World Forum for Harmonization of Vehicle Regulations**Working Party on Noise****Fifty-sixth session**

**Regulation No. 51 (Noise of M and N categories
of vehicles) — New limit values****Proposal for Supplement 8 to the 02 series of amendments to
Regulation No. 51 (Noise of M and N categories of vehicles)****Submitted by the expert of the Netherlands¹**

This proposal was prepared by the expert from the Netherlands, updating the requirements on the noise test track to the latest stage of the applicable ISO standards: from ISO 10844:1994 to ISO 10844:2011. The proposal also incorporates draft transitional provisions to allow repaving of existing, non-complying test tracks with these ISO standards. The proposal contains two alternatives for consideration by the Working Party on Noise (GRB), one referring to ISO standard 10844:2011 and the other reproducing the whole text of the standard. The modifications to the text of the UN Regulation are marked in bold for new or strikethrough for deleted characters.

Figure 1:
Minimum requirement for test surface area. The shaded part is called "Test Area".

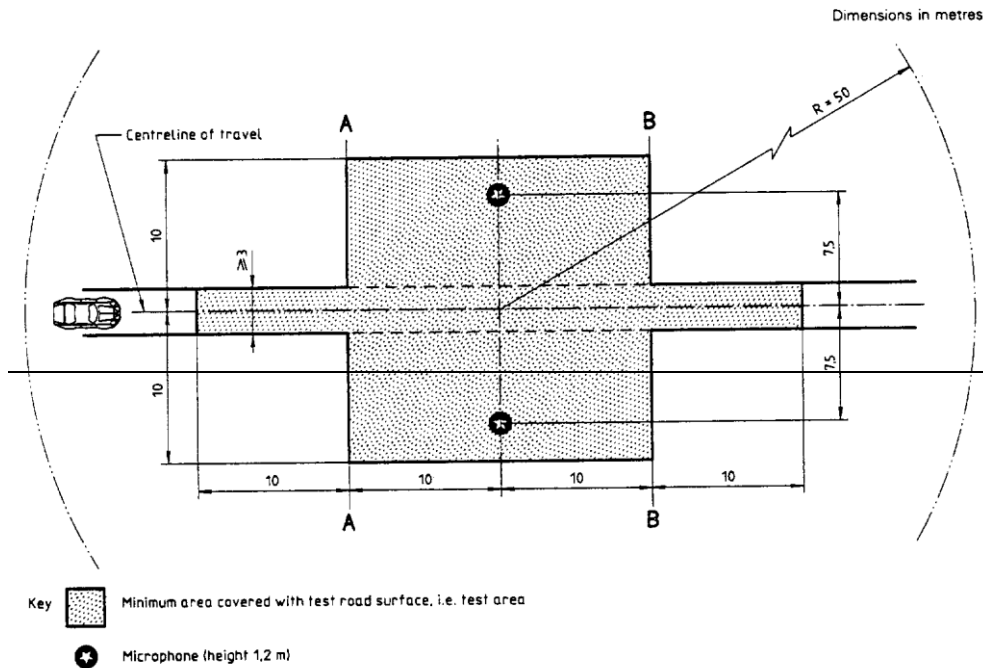
~~When designing the test track layout it is important to ensure that, as a minimum requirement, the area traversed by the vehicles running through the test strip is covered with the specified test material with suitable margins for safe and practical driving. This will require that the width of the track is at least 3 m and the length of the track extends beyond lines AA and BB by at least 10 m at either end. Figure 1 shows a plan of a suitable test site and indicates the minimum area which shall be machine laid and machine compacted with the specified test surface material. According to Annex 3, paragraph 3.1.1.1., measurements have to be made on each side of the vehicle. This can be made either by measuring with two microphone locations (one on each side of the track) and driving in one direction, or measuring with a microphone only on one side of the track but driving the vehicle in two directions. If the latter method is used, then there are no surface requirements on that side of the track where there is no microphone.~~

Figure 1
Size of the test track

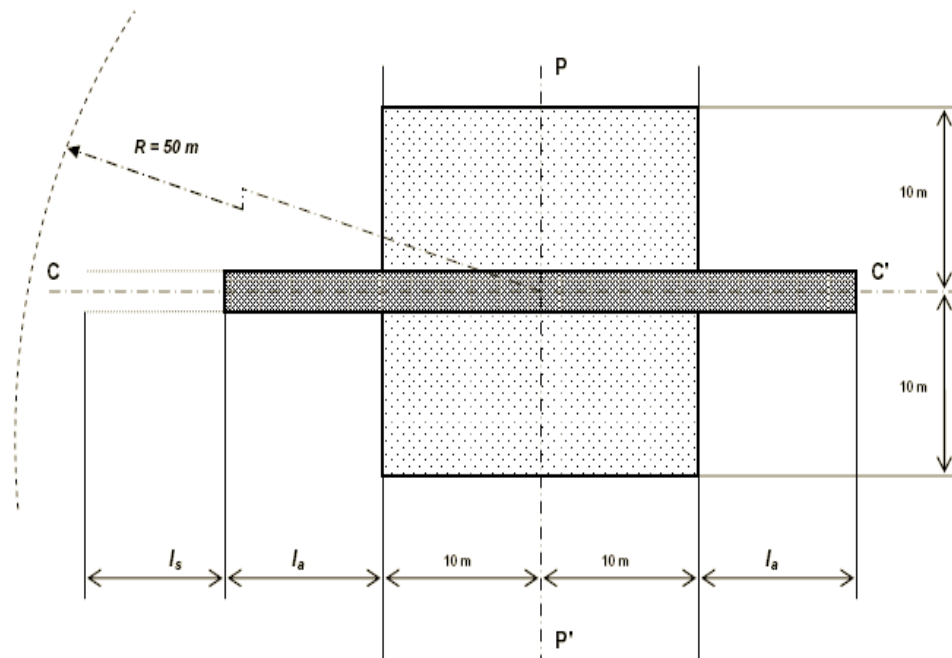
The test track shall consist of two areas, a drive lane and a propagation area. The dimensions shall comply with Figure 1 and Table 1.

A drive lane with a length of l_a and width of at least 3.0 m that is centered around line PP'. The value of l_a is defined in Table 1.

The propagation area shall extend at least 10 m from the centre of the drive lane and at least 10 m at both sides of the line PP'.

Figure 2
Propagation area slope in transverse direction

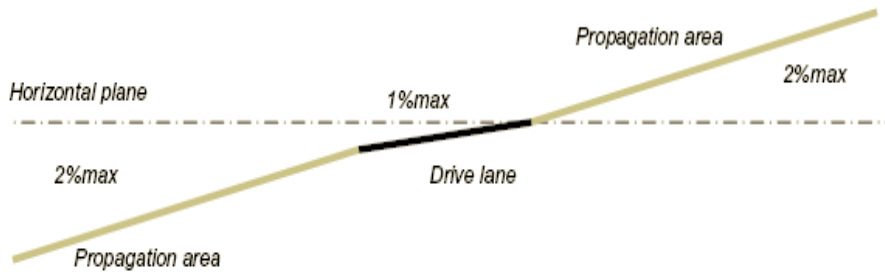
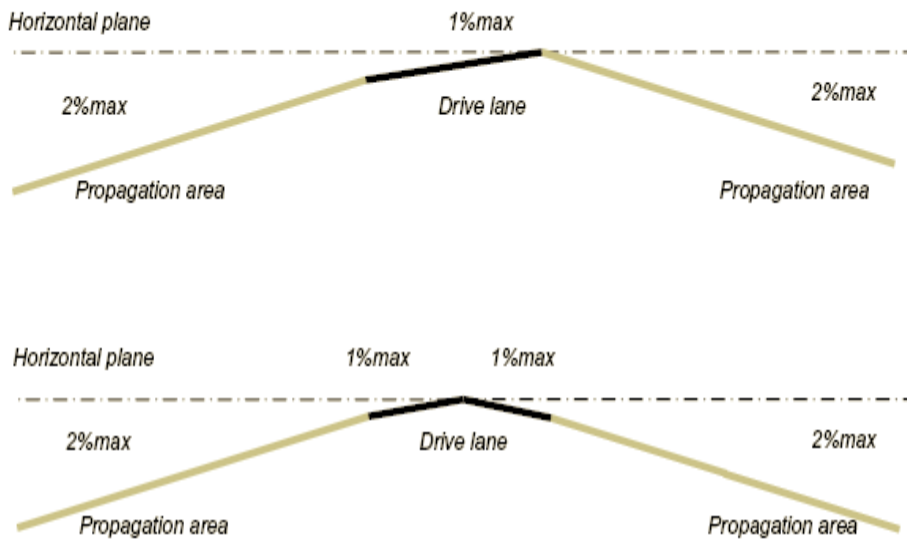
- (i) The propagation area shall have irregularities equal to or less than 0.02 m measured with the straightedge according to EN 13036-7;
- (ii) The propagation area may have one or both sides lower than the drive lane. Cross fall in transverse direction, measured using an appropriate instrument, shall be equal or less than 2.0 per cent (see Figure 2);

1 per cent max: allowed drive lane cross fall

2 per cent max: allowed propagation area cross fall

Propagation area – Steps or discontinuities

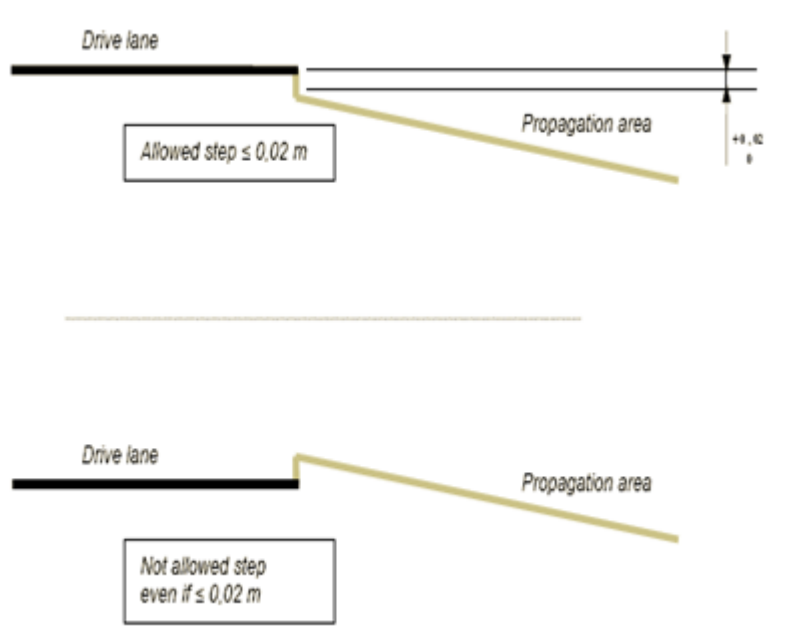
Steps or discontinuities between the propagation area and the drive lane shall be between 0 and +0.02 m. Negative steps are not allowed (see Figure 3).

Figure 4
Sieving curve area

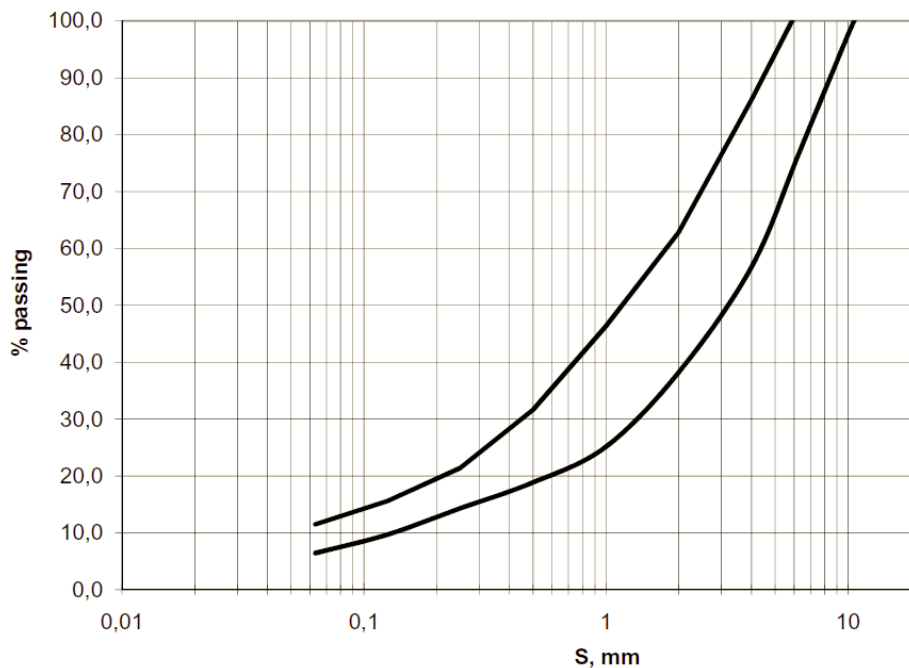
- (a) be of dense asphalt concrete;
- (b) exhibit a sound absorption equal to or less than 8 per cent in any one-third-octave band between 315 Hz and 1 600 Hz when measured according to 4.3;
- (c) have a maximum chipping size of 8 mm (tolerance allowed between 6.3 mm to 10 mm);
- (d) have a thickness of the wearing course greater than or equal to 30 mm;
- (e) have a Mean Profile Depth measured according to ISO 13473-1 of $0.5 \text{ mm} \pm 0.2 \text{ mm}$;
- (f) have a target sieving curve for the aggregate as shown in Figure 4.

Measurement positions on test track, example for $l = 40$ m

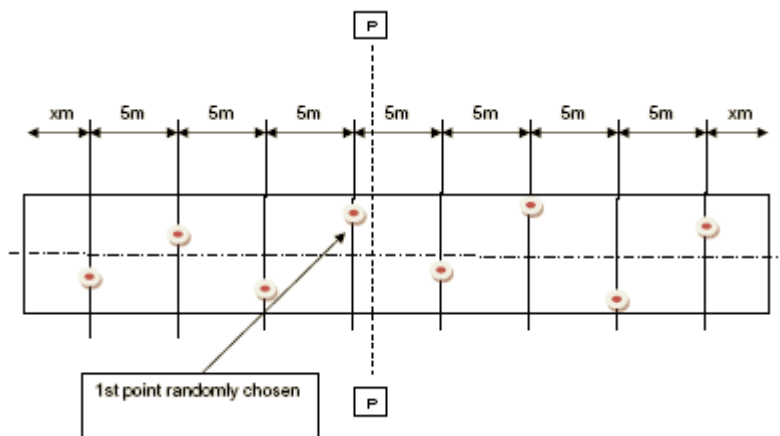
- (a) The surface properties for each requirement shall be determined at the following measurement points before the acceptance of the track (refer to Table 2);
- (b) During the periodical checking of the track (refer to Table 2);
- (c) All measurements shall be made along the total length of the drive lane in each wheel track according to Figure 5;
- (d) For sound absorption, texture, geometrical compliance, the first point shall be chosen randomly on each side test of the line PP' and the subsequent measurements shall be performed at 5 m intervals not on the same axis of the centre line to cover the whole track;

- (e) After construction, take a total of four cores, preferably at 10 m intervals outside the wheel tracks on the driving lane run up section, and measure the sieving curve from these samples.
